**MEETING OF THE
PLANNING AND ZONING BOARD
QUASI-JUDICIAL PUBLIC HEARING**

May 21, 2019

**TOWN OF BAY HARBOR ISLANDS
DRC STAFF
PLAN REVIEW**

**RE: BELIZA 1170 102 STREET
RESPONSE TO COMMENTS BY MICHAEL MILLER PLANNING ASSOCIATES, INC.**

ROOF PLAN

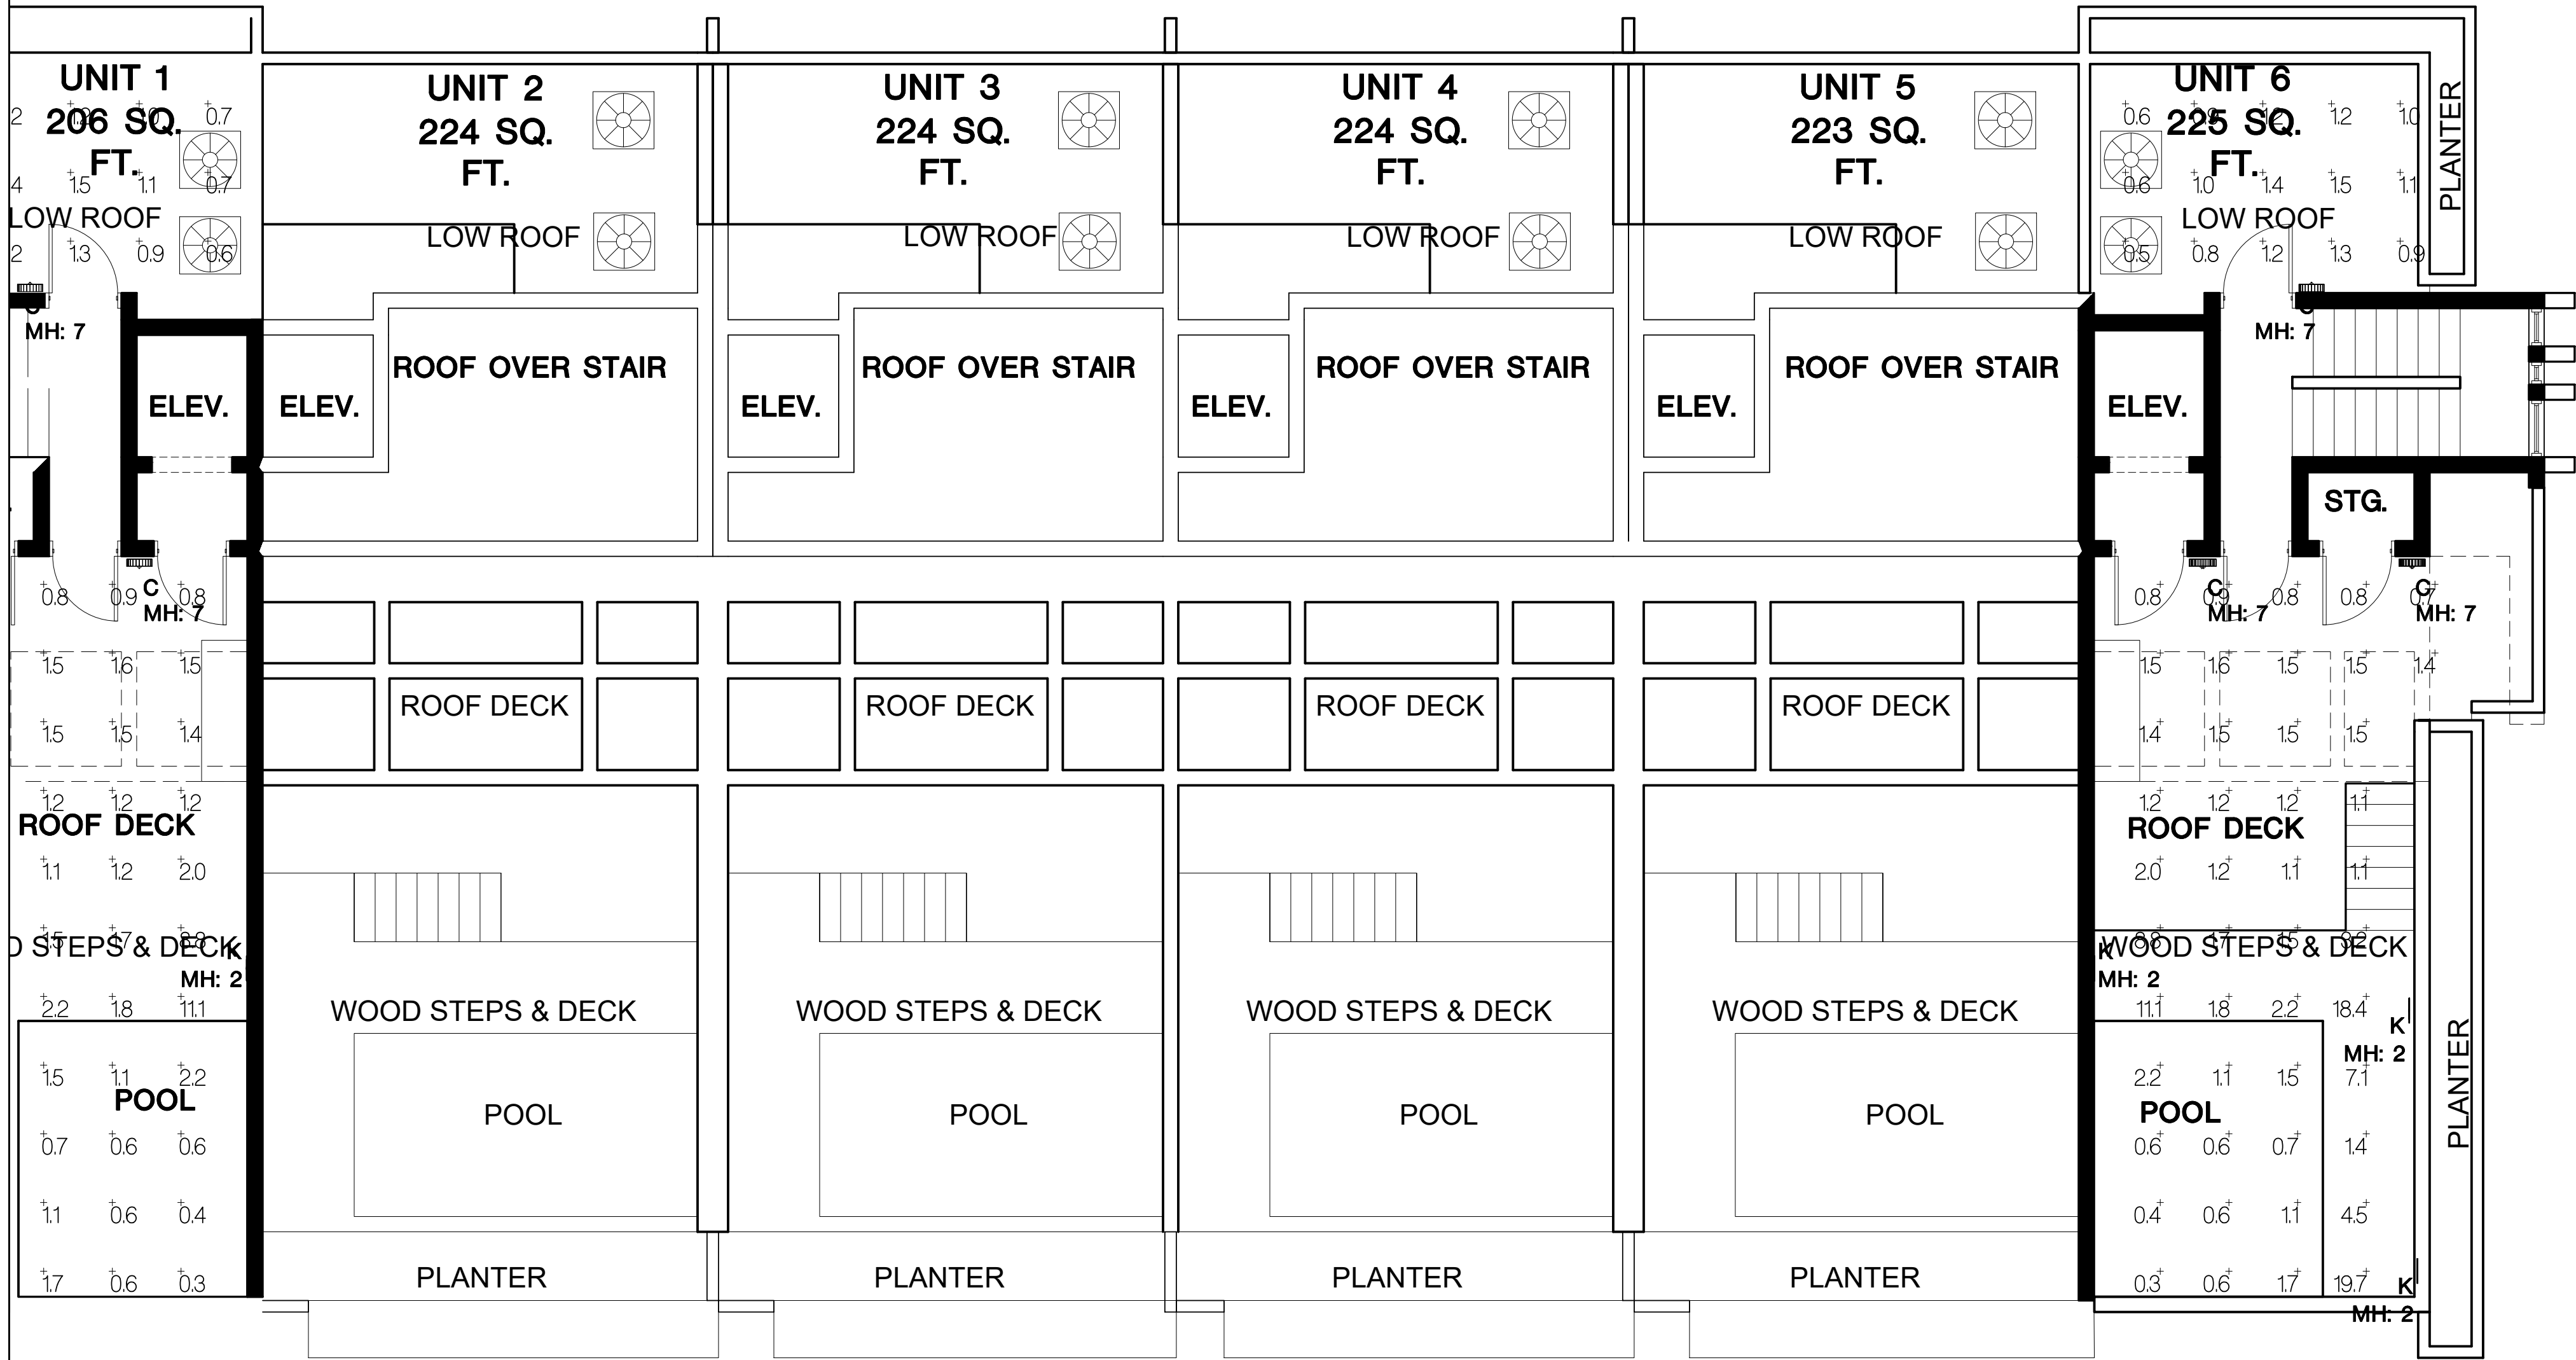
THE PHOTOMETRIC LIGHTING PLAN IS INCOMPLETE; MISSING ITEMS 23-19€(2)(d), (e), (f) AND (h)

Please note that we submitted 3 sheets of Photometric Plans including Level 1/Site, Level 4 Roof, Level 5 Roof. The Luminaire Schedule shows the lumens, the watts, the manufacturer, the mounting heights, and all illumination values in fc. We also include in this submittal the cut sheets for all exterior lighting fixtures. During our DRC review Michael Miller agreed that the Photometric Plans are satisfactory.

P & Z PROPOSED REVISION

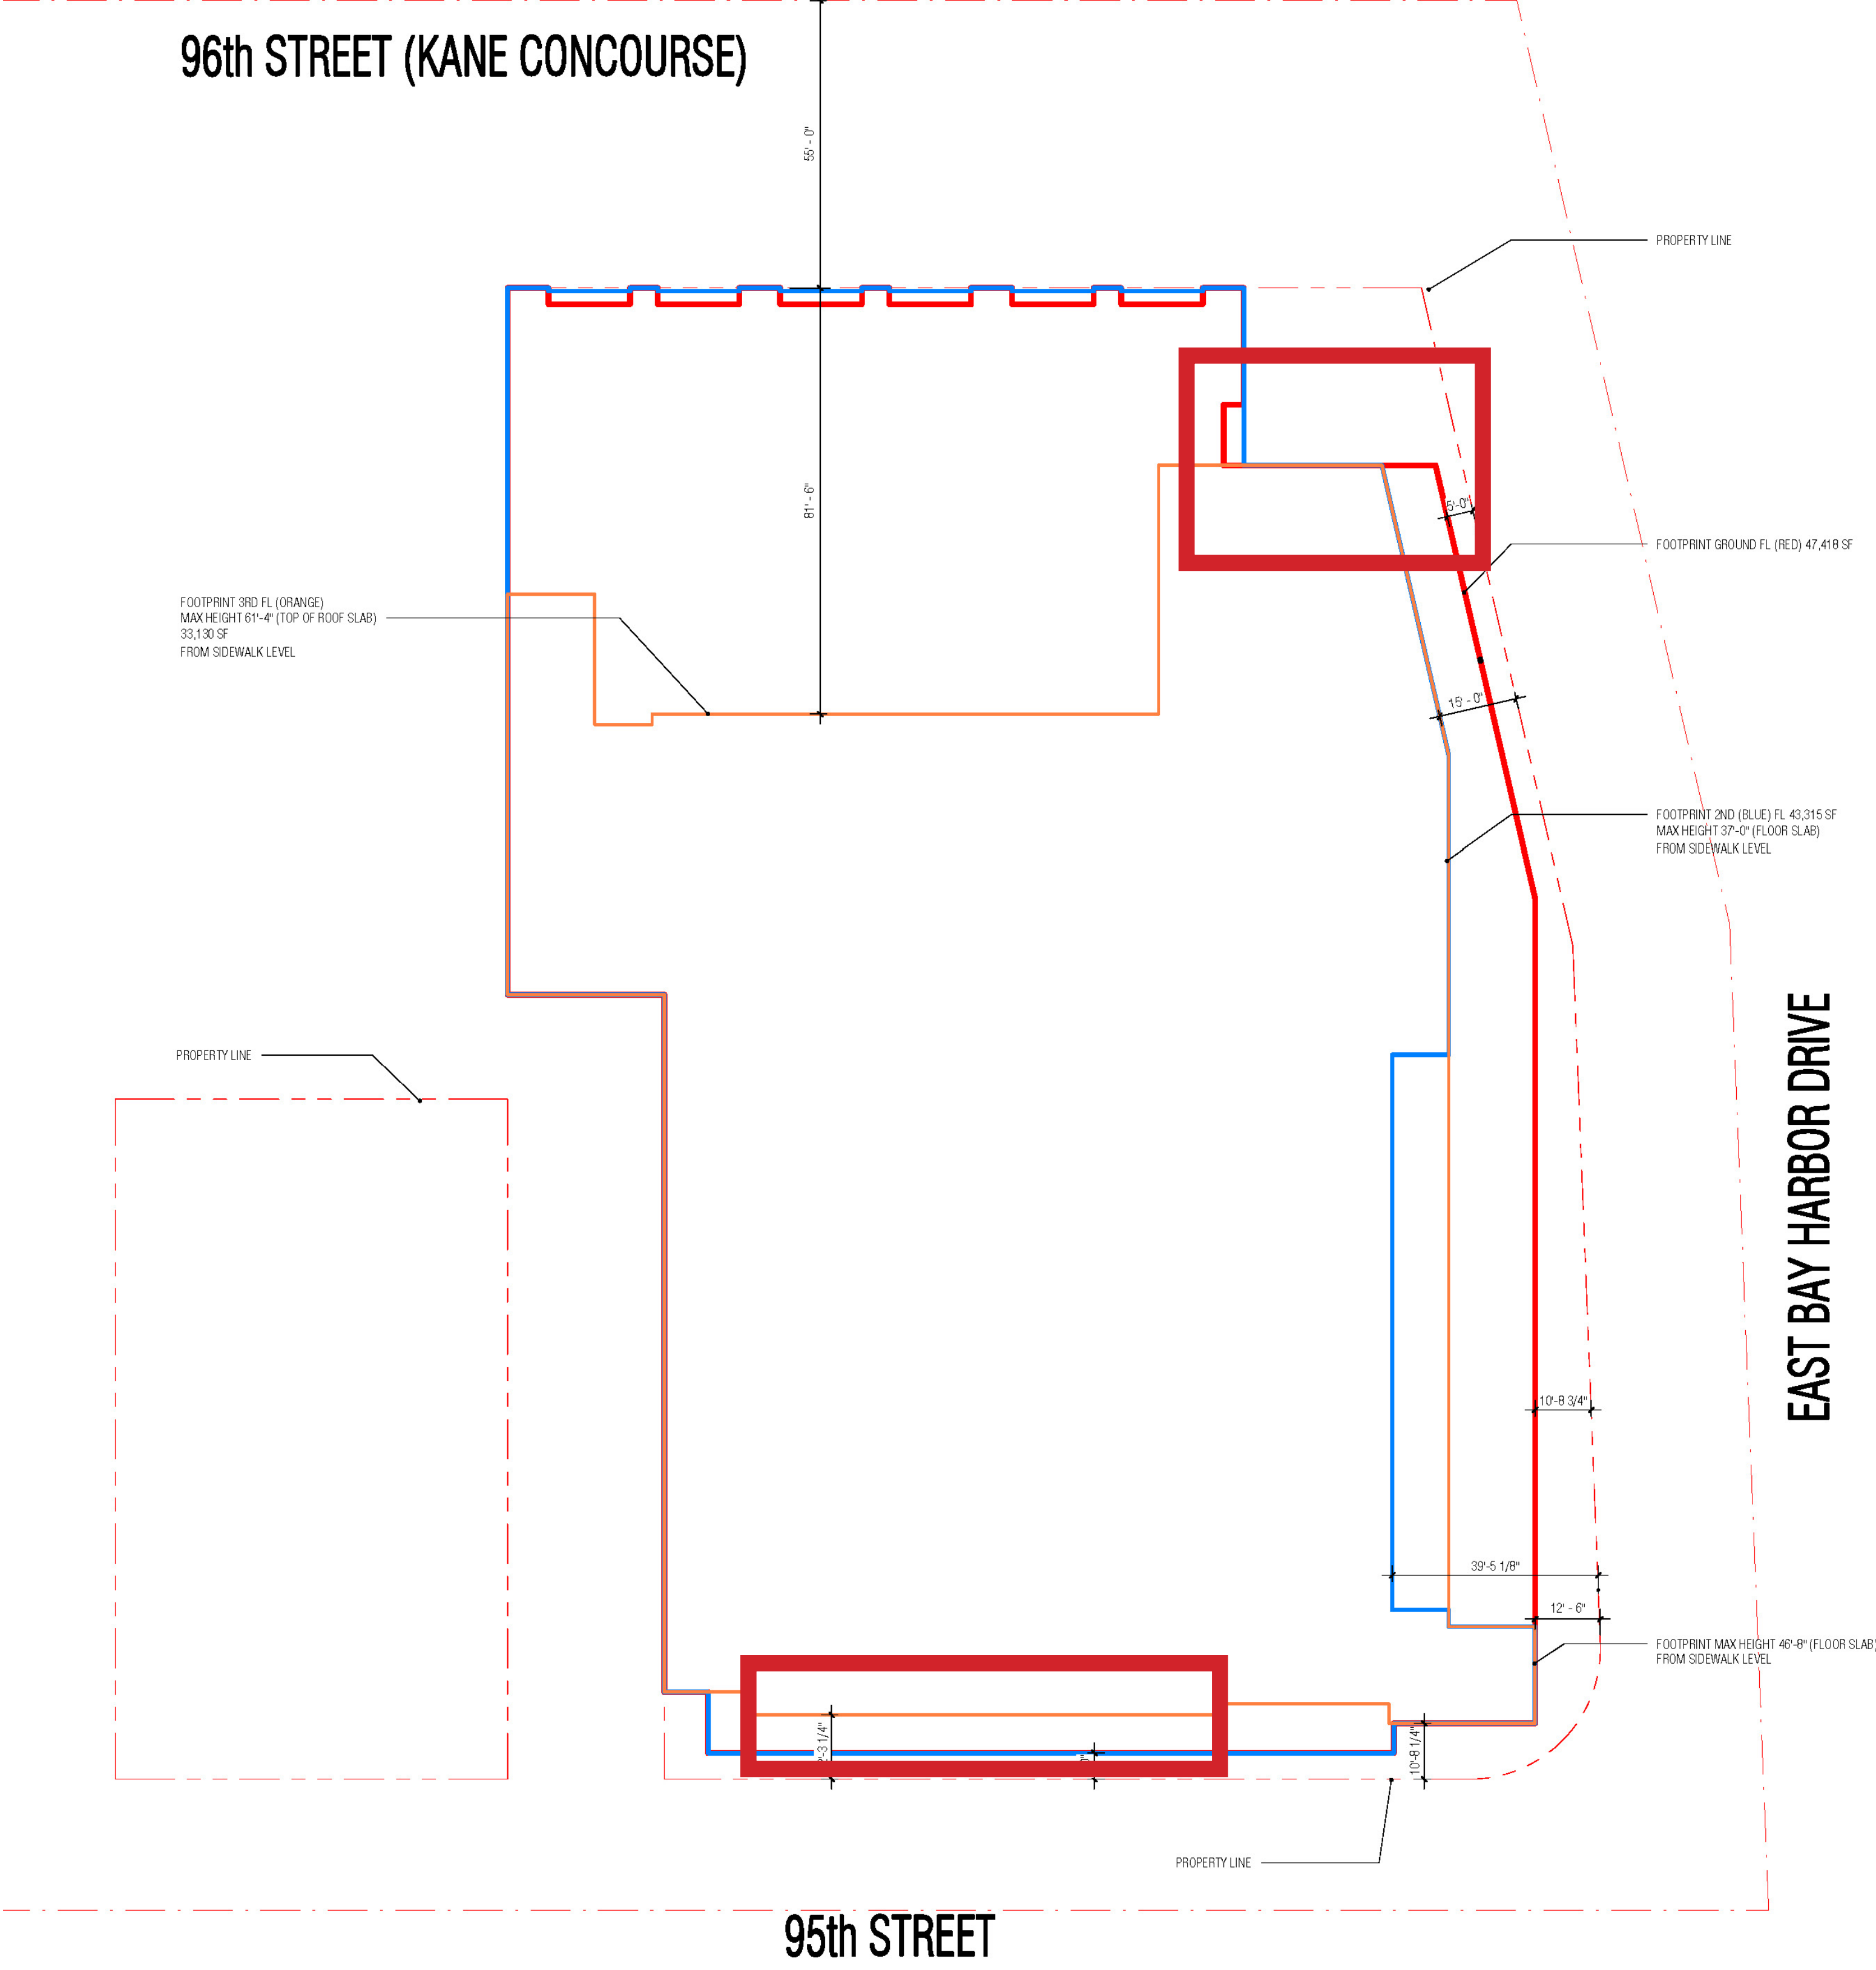
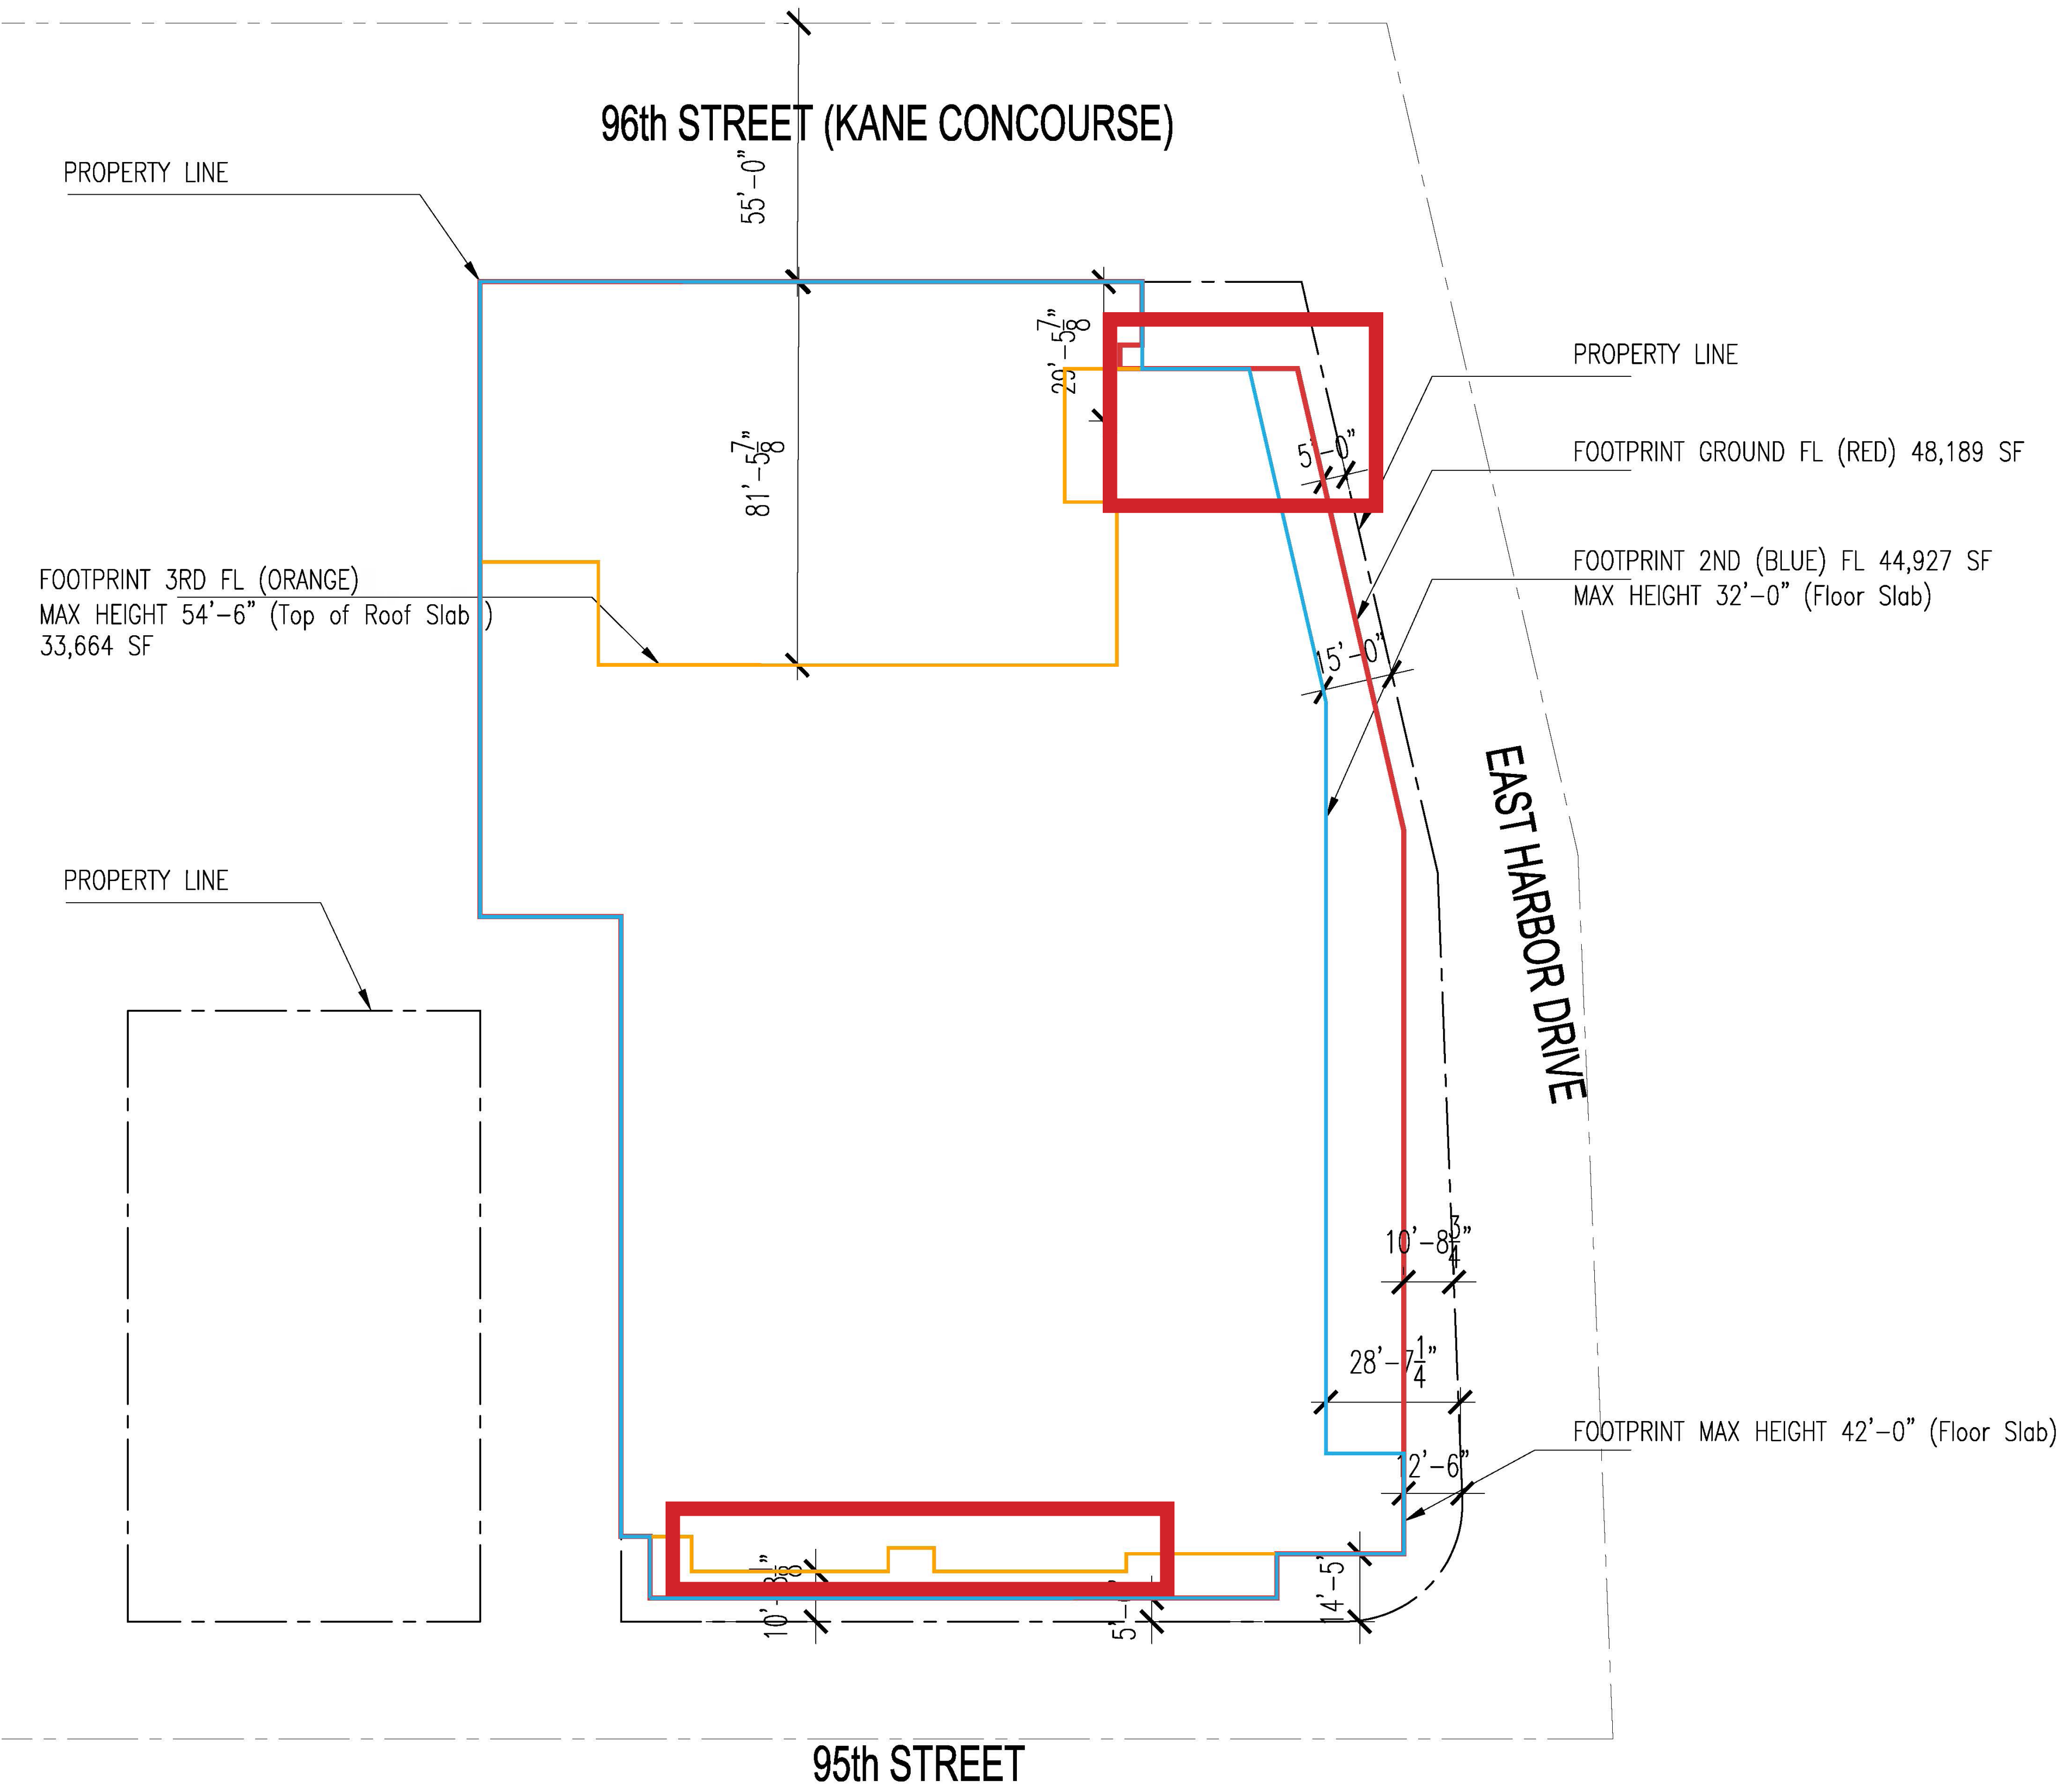
STEEPLE PUSHED BACK AS PER CONDITIONS OF APPROVALS; SANCTUARY SOUTH WALL MOVED BACK 1'-7" TOWARDS THE NORTH
